# AUBURN HILLS 2ND ADDITION

Re: S/D 96-37 - One Step Preliminary-Final Plat of the AUBURN HILLS 2nd ADDITION

At the regular meeting of the Subdivision Committee of the Metropolitan Area Planning Commission on Thursday, June 20, 1996, the above captioned plat was considered. The action of the Committee was to recommend that this plat be approved subject to:

**CASE NUMBER:** S/D 96-37 AUBURN HILLS 2ND ADDITION

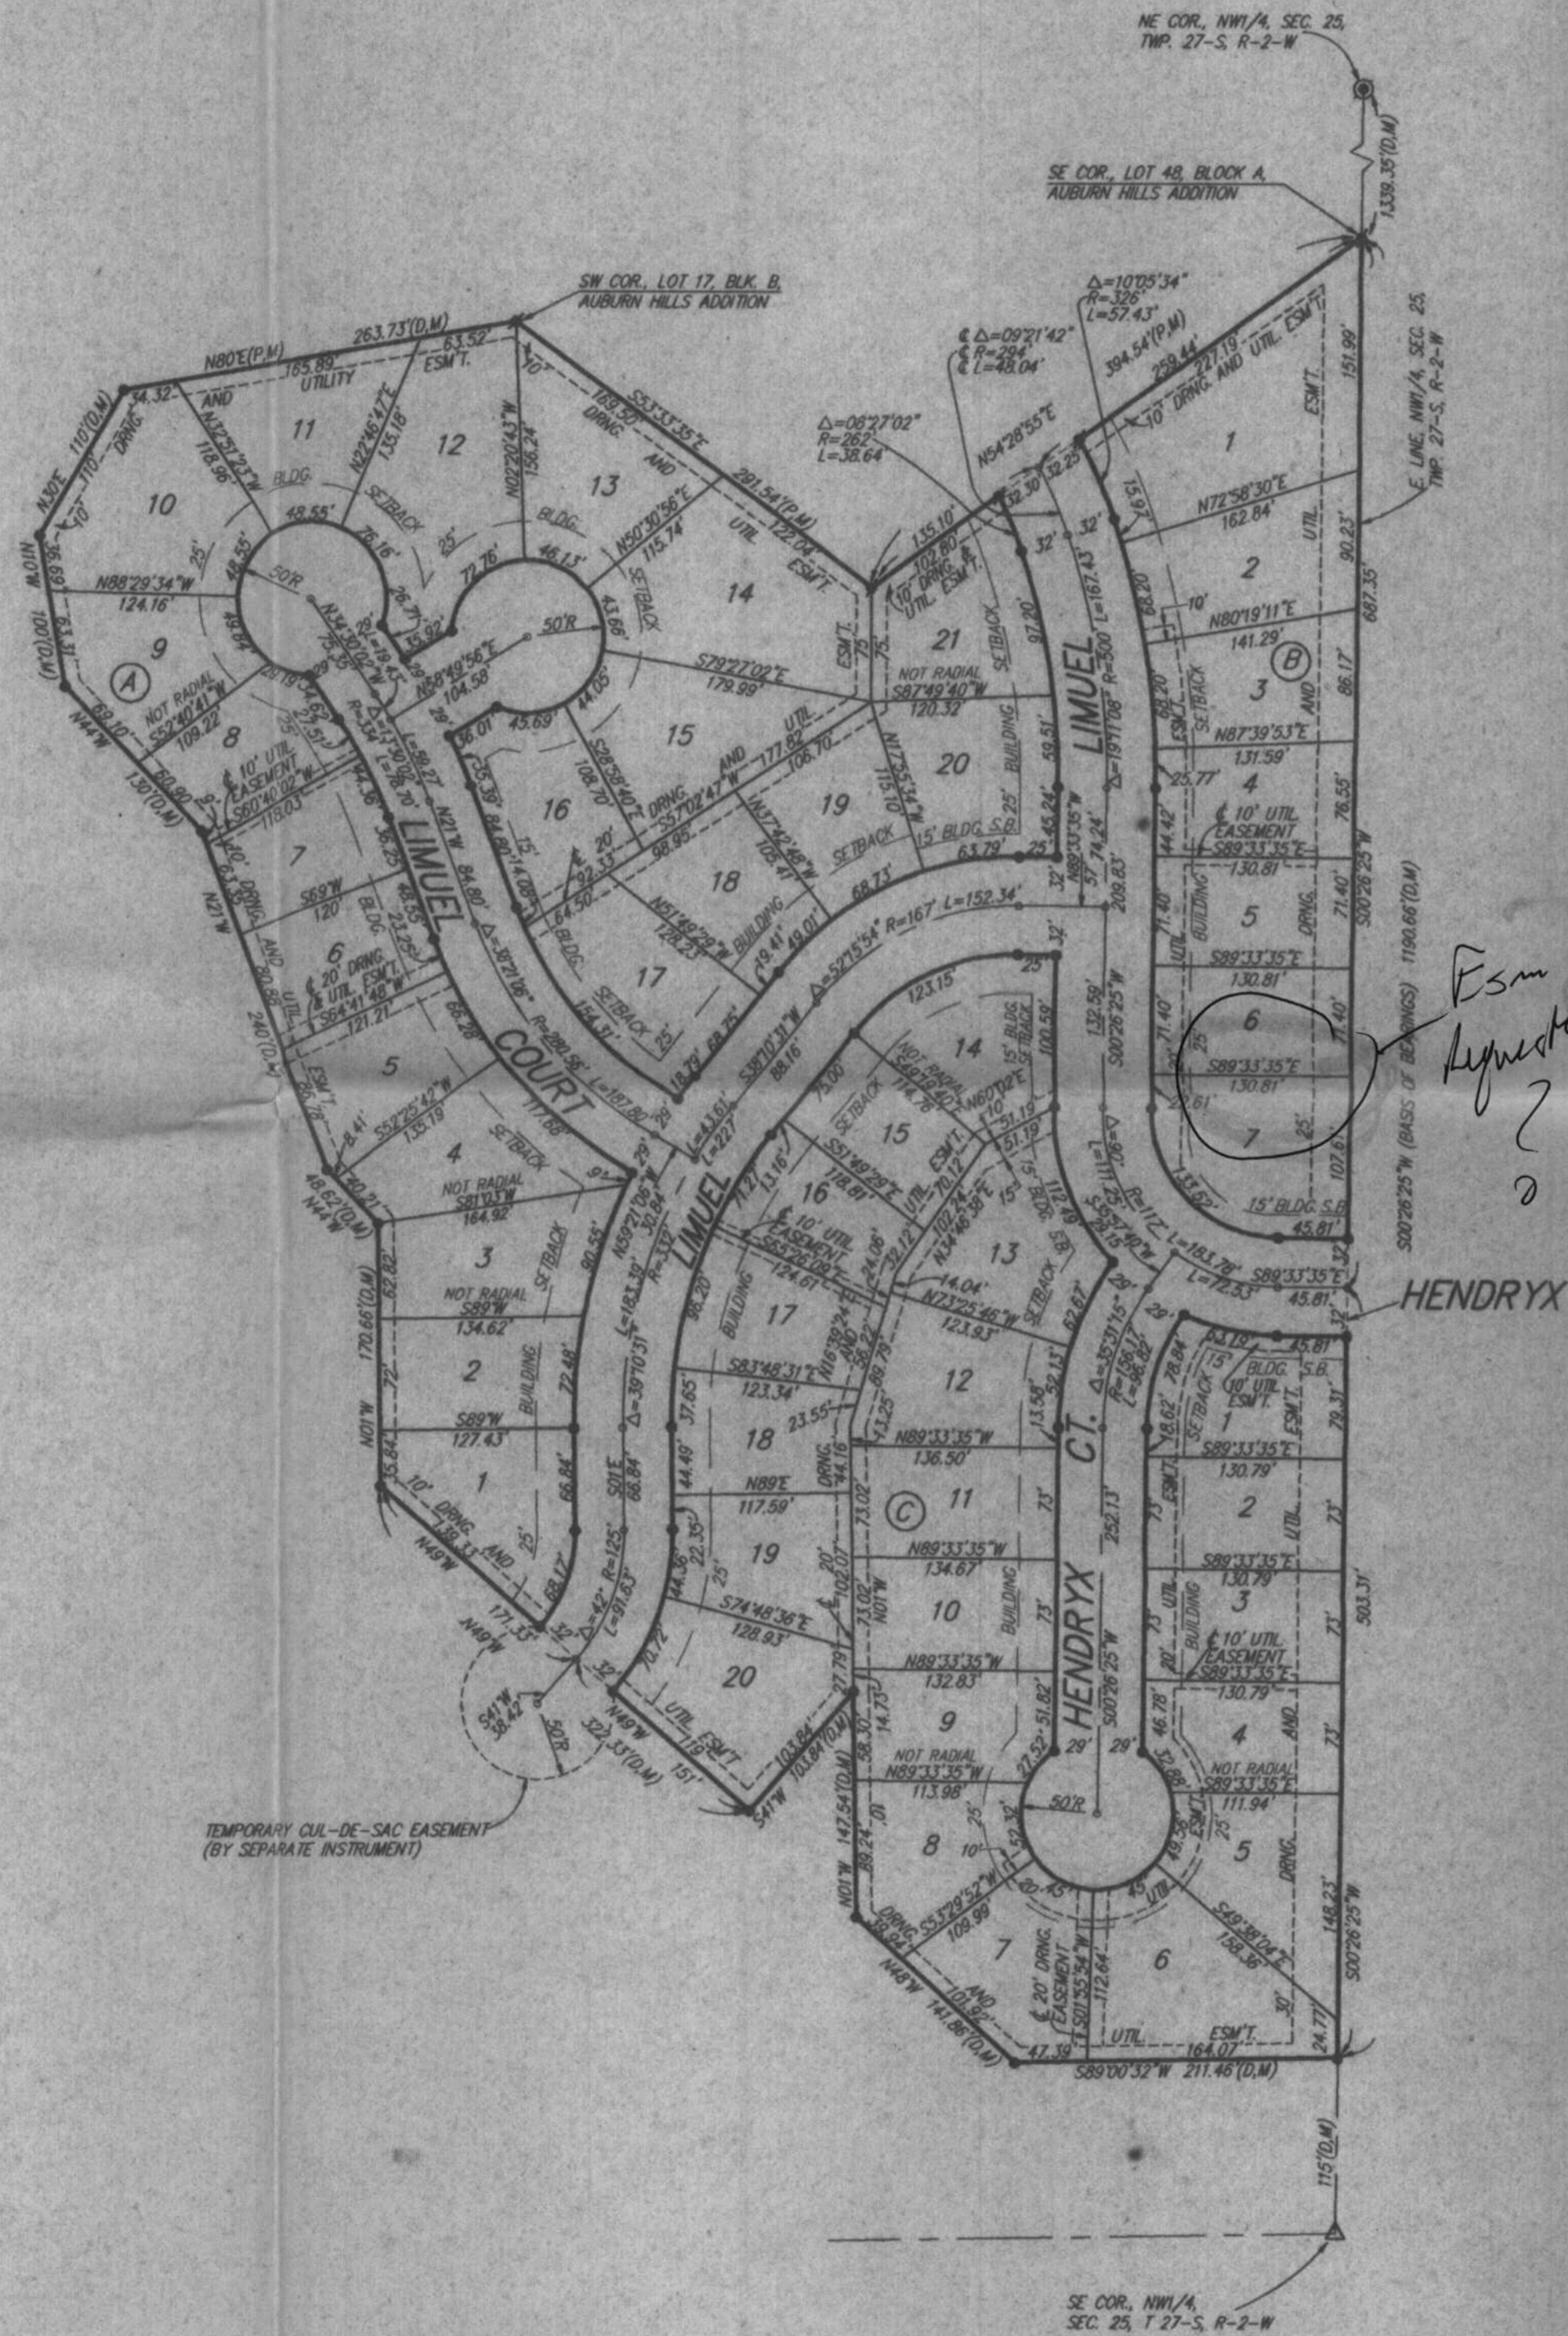
- I. The off-site temporary cul-de-sac needs to be created by separate instrument. Such instrument should be submitted to Planning for processing with the final plat tracing.

- K. On the final plat tracing, the City's signature block shall be amended by deleting "Deputy" from the City Clerk's signature line.
- L. If additional, off-site utility easements are required along the west line of this plat, these easements shall be granted by separate instrument and submitted to Planning for processing with the final plat tracing.

- M. On the final plat tracing, Lot 16, Block A shall be properly depicted. The plat presently shows two (2) Lot 17's at that area of the plat.
- N. The applicant shall install or guarantee the installation of all utilities and facilities which are applicable and described in Article 8 of the MAPC Subdivision Regulations. (Water service and fire hydrants required by Article 8 for fire protection shall be as per the direction and approval of the Chief of the Fire Department.)

- T. The final plat shall indicate the utility easements requested by K.G.& E. which are indicated on the enclosed "marked" copy of the plat.

U. The City Fire Department indicated that there are 90° turns on Hendryx and Limuel. The applicant should contact Central Inspection for addressing purposes.
